HISTORIC AND DESIGN REVIEW COMMISSION

October 16, 2024

HDRC CASE NO: 2024-344
COMMON NAME: E Market at Hemisfair District
LEGAL DESCRIPTION: NCB 13814 (HEMISFAIR - NORTHWEST QUADRANT), BLOCK 3
LOT 20
ZONING: D, H, RIO-3, Public Property
CITY COUNCIL DIST.: 1
DISTRICT: Hemisfair Historic District
APPLICANT: FitzGerald Associate Architects, PLLC
OWNER: Trube Land Development
TYPE OF WORK: Construction of a 10-story, mixed-use structure, and construction of a 3-story, retail structure
APPLICATION RECEIVED: September 25, 2024
60-DAY REVIEW: November 24, 2024
CASE MANAGER: Edward Hall
REQUEST:

Market Street Podium Facade Articulation

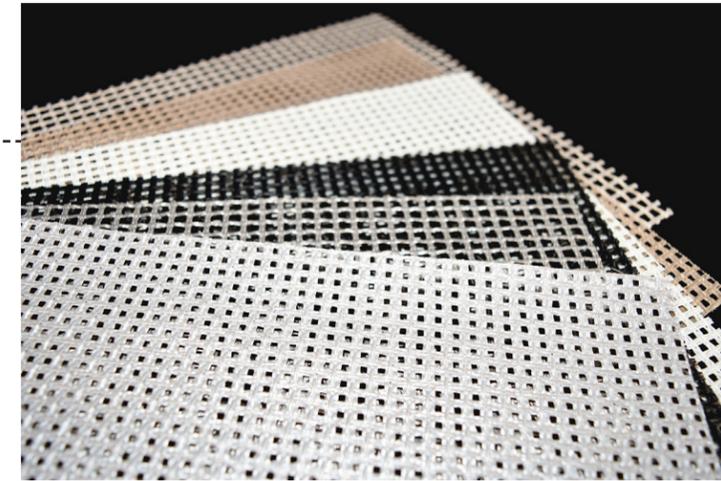
- ii. That the proposed CFPS system should be detailed and applied to present an appearance similar to applied stucco, with expansion joints comparable to stucco, as noted in finding 2f. Stucco should be true stucco with a traditional troweled finish where highly visible from the ROW. The coarse stucco noted in the application documents should not be used.
